From: [Kim Burstein](#)
To: [Lia Niebauer](#)
Subject: [EXTERNAL]For Oct. 6 BAR meeting-Heritage
Date: Sunday, October 3, 2021 6:25:34 PM

From: [martha.raymond](#)
To: [Lia Niebauer](#)
Subject: [EXTERNAL]Heritage project - BAR Hearing—October 6, 2021, Docket # 2021-00341-Letter Submission
Date: Tuesday, October 5, 2021 9:11:09 AM

Subject: BAR Certificate of Appropriateness Application dated June 21, 2021

PER APPLICANT

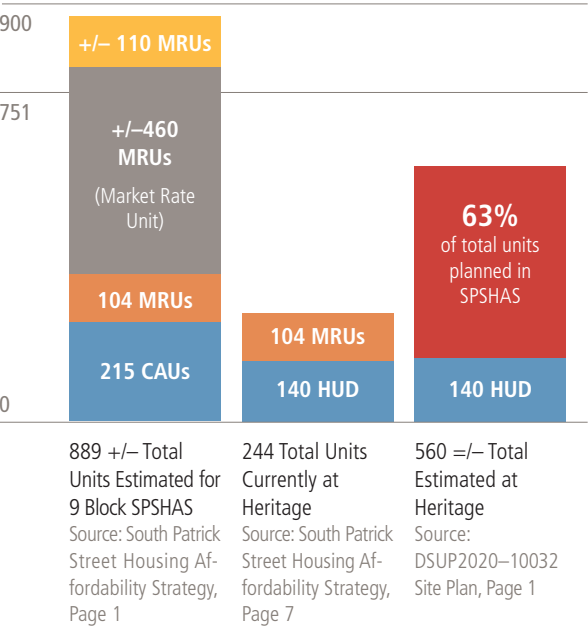
Height of +/- 80 ft does not comply with RMF Zone Limit or Strategy Limit

Increase of 46 affordable units with 91 extra bonus density units **does not** comply with RMF Zone. RMF Zone is to **preserve** affordable units.

Per Applicant

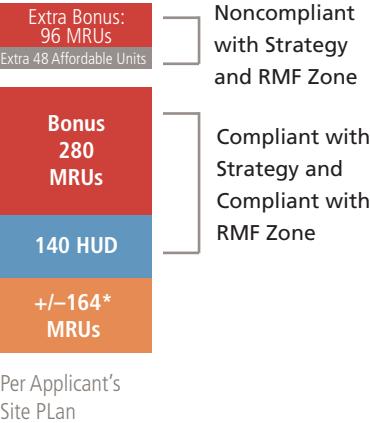
Increase of 46 affordable units with 91 extra bonus density units does not comply with RMF Zone.

HEIGHT of +/-80 feet site plans exhibit noncompliance with RMF zone ordinance and Strategy ordinance.

HERITAGE DEVELOPMENT: BLOCKS 1 AND 2 OPEN SPACE

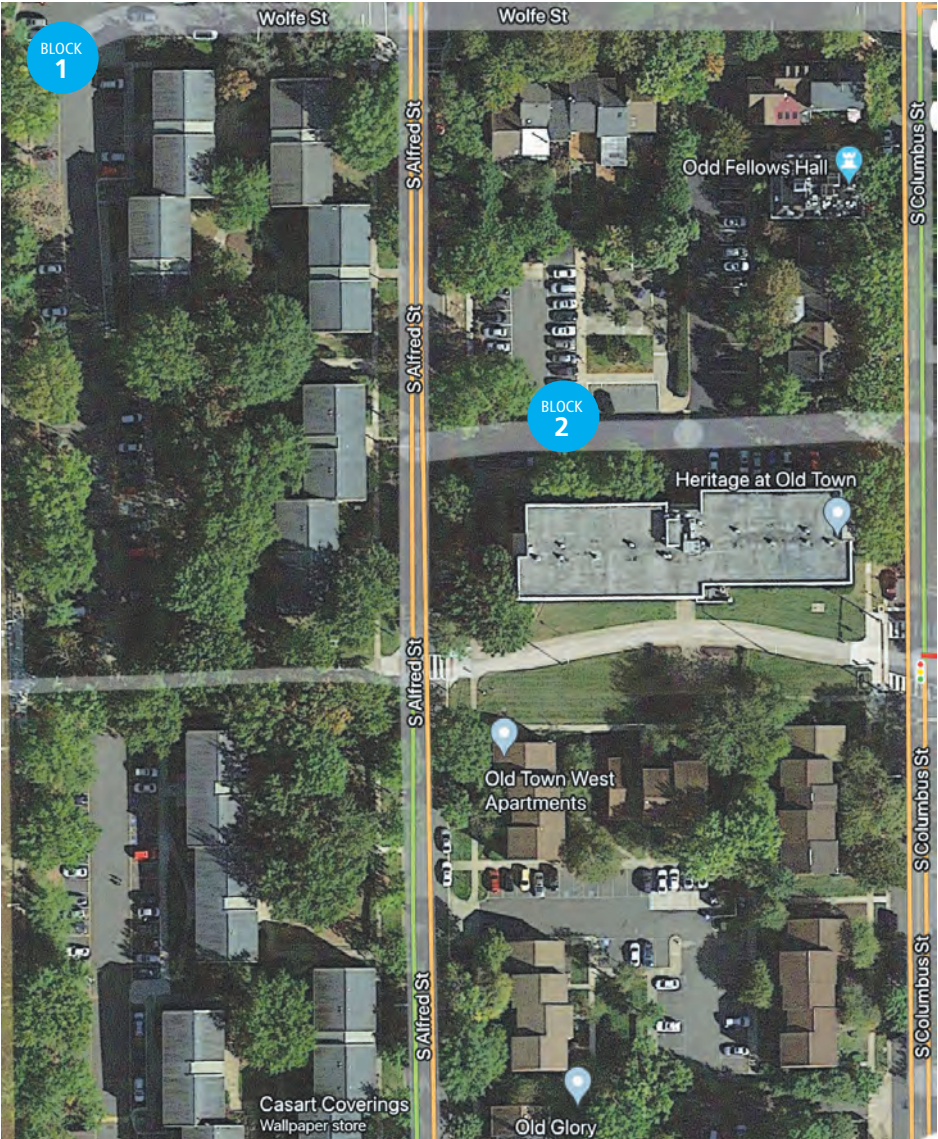
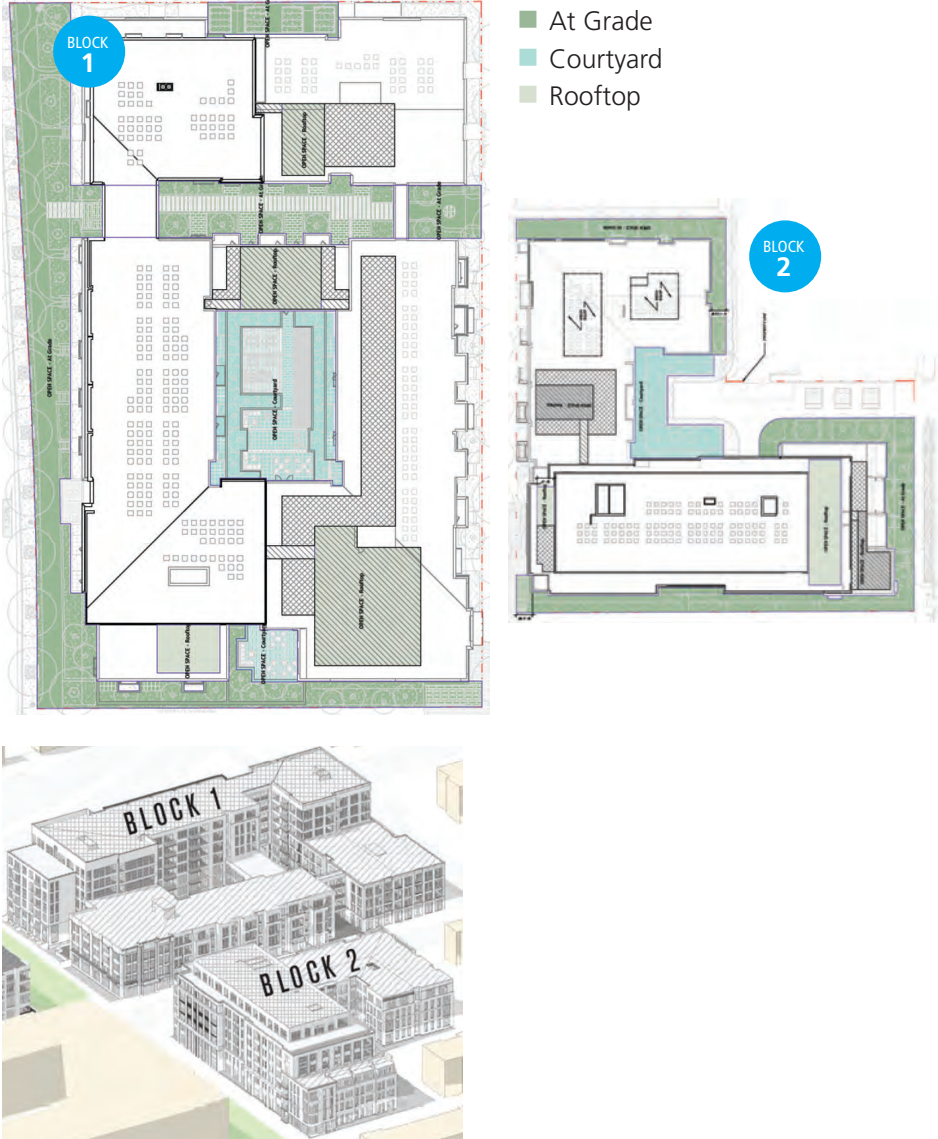
The project's mass is directly related to its site coverage. Based on the documentation submitted for the docket (Page 69) the site area of Blocks 1 and 2 is 207,158 SF (4.75 Acres) and the required Open Space is 51,790 SF (25% of the site area). From the existing Demolition Plans (Pages 62 & 64) the existing buildings cover about 29,940 SF leaving 85.5% of the site as open space. The Proposed buildings (Pages 74 & 76) would leave 42,330 SF as open space which includes rooftop and courtyard areas that are not appropriately considered open space. Since the proposed buildings would leave only 20.4% of the sites as open space the request for Appropriateness should be denied.

Existing Open Space of Blocks 1 and 2 is 177,222 SF (85% Open Area)

HERITAGE DEVELOPMENT: BLOCK 2 BUILDING HEIGHT

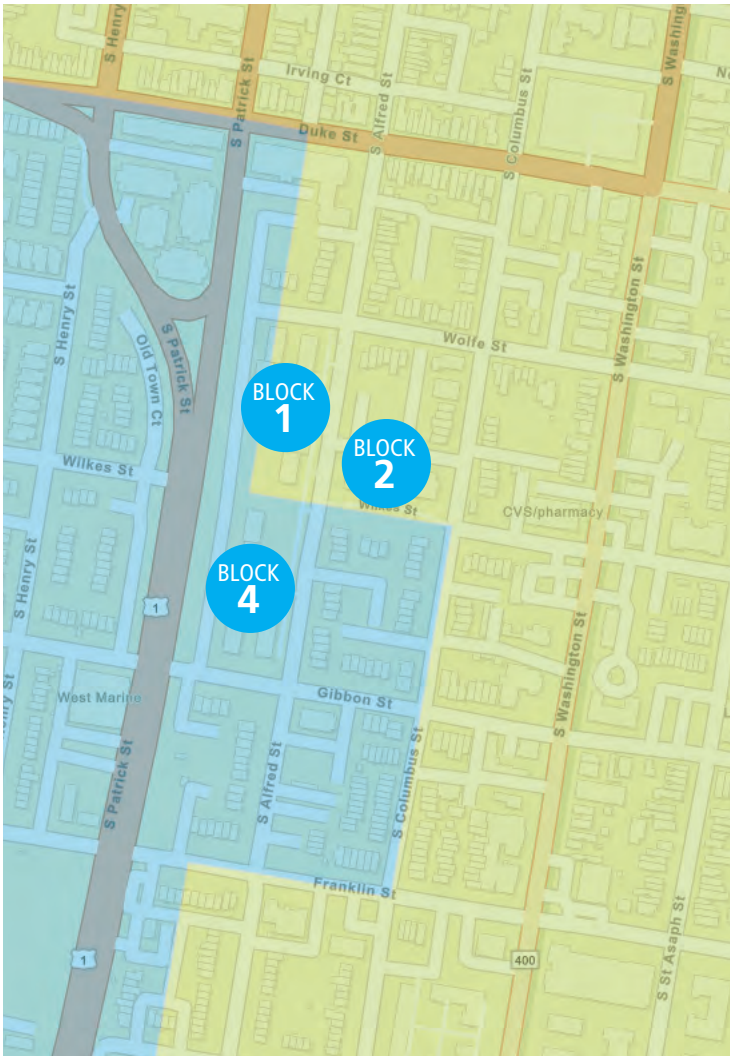
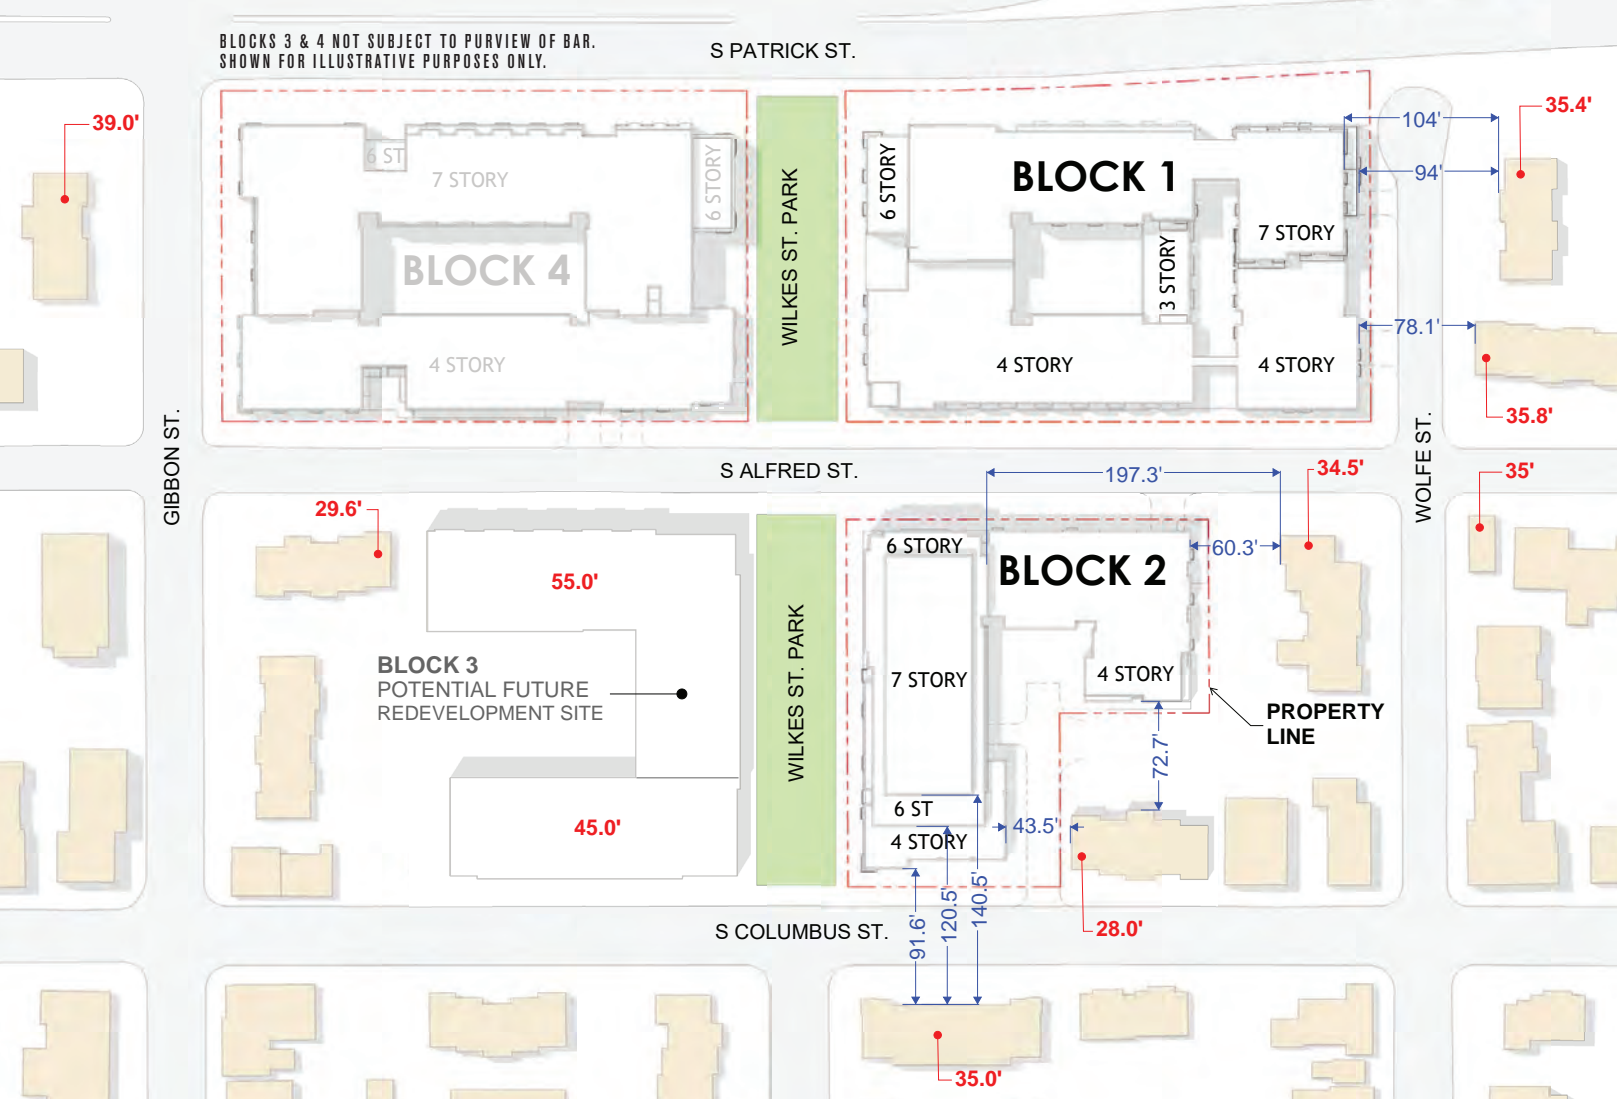
- HD1 = Old and Historic District
- HD1 Height Limit = 50 feet
- Block 2 is in HD1 Height District Map
- Block 2 Height per City Old Town Height Limit is 50 feet

HERITAGE DEVELOPMENT PLANS: BLOCK 1

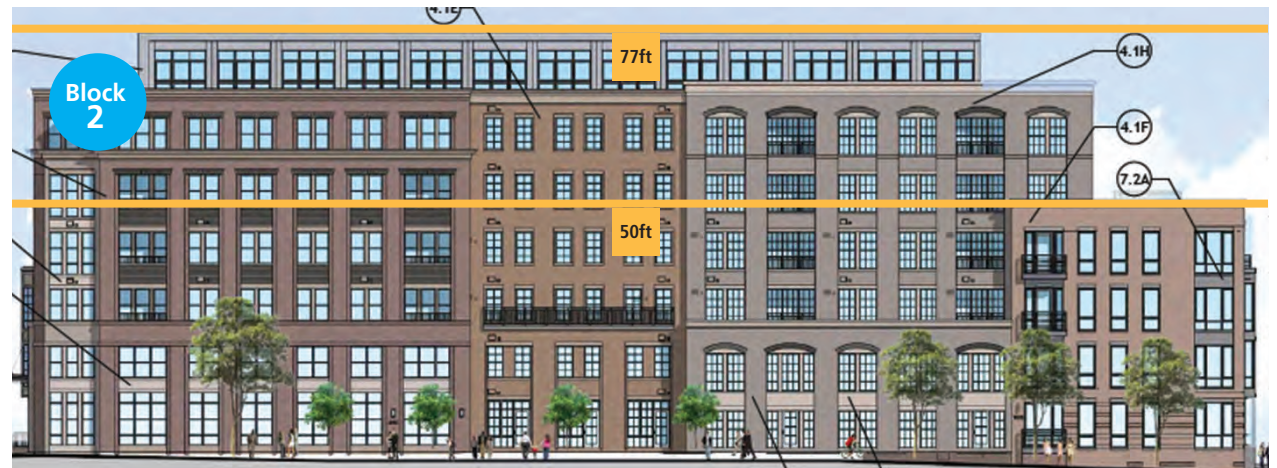
- Not compatible with existing neighborhood character.
- Building height, mass & scale is dominating the neighborhood of 2–3 story townhouses.

HERITAGE DEVELOPMENT PLANS: BLOCK 4

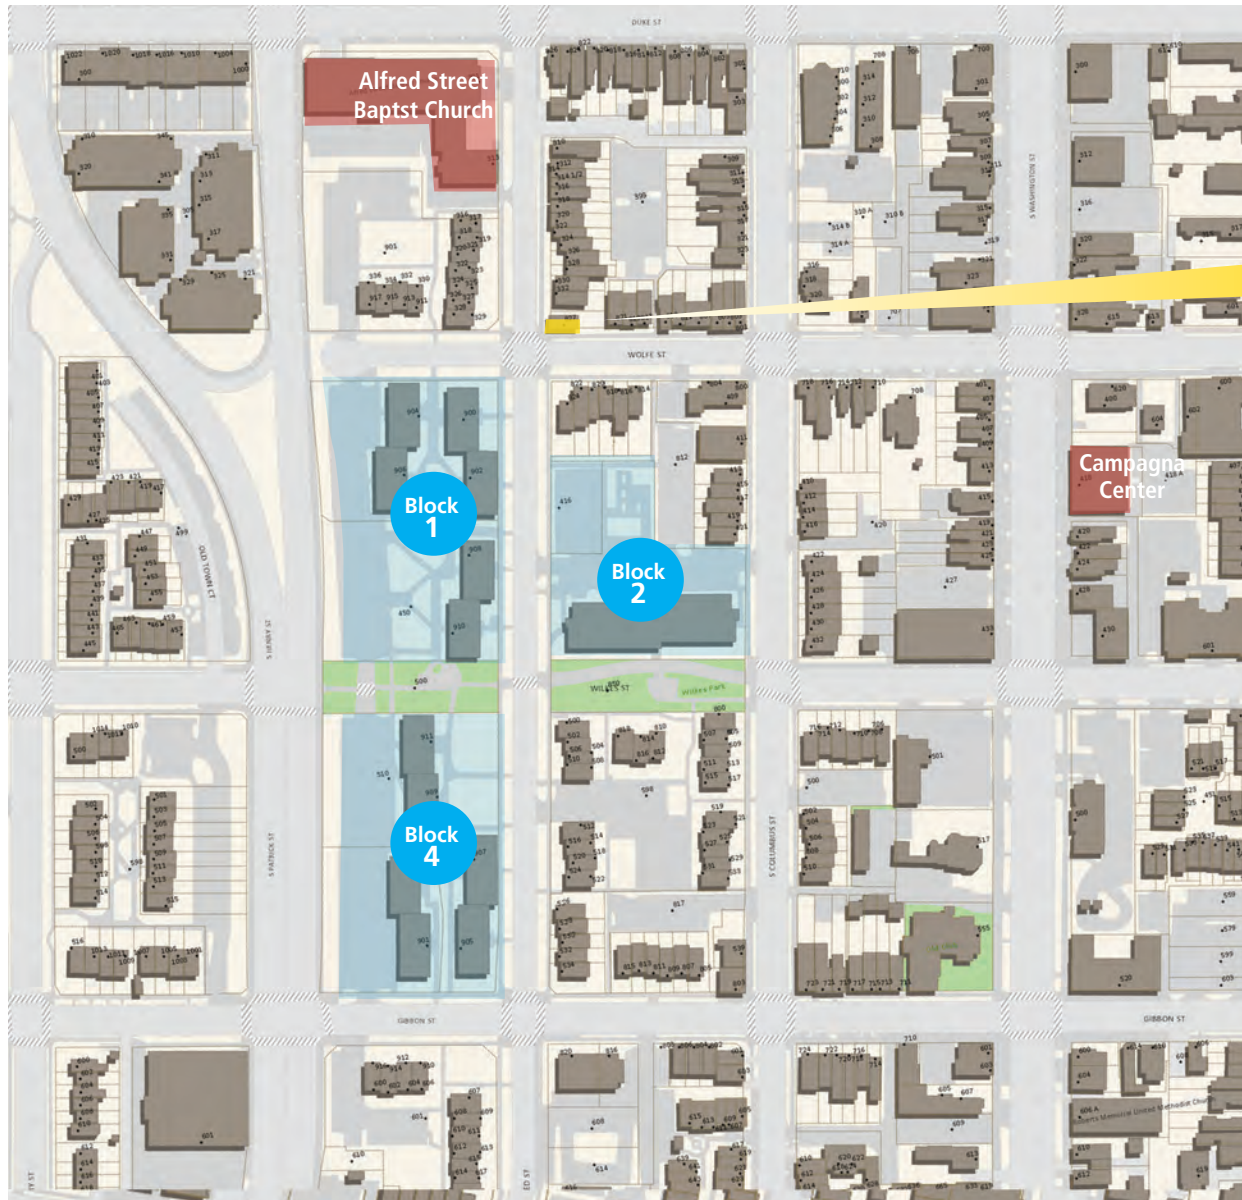
- Building height, mass & scale is dominating the neighborhood of 2–3 story townhouses.
- Not compatible with existing neighborhood character.
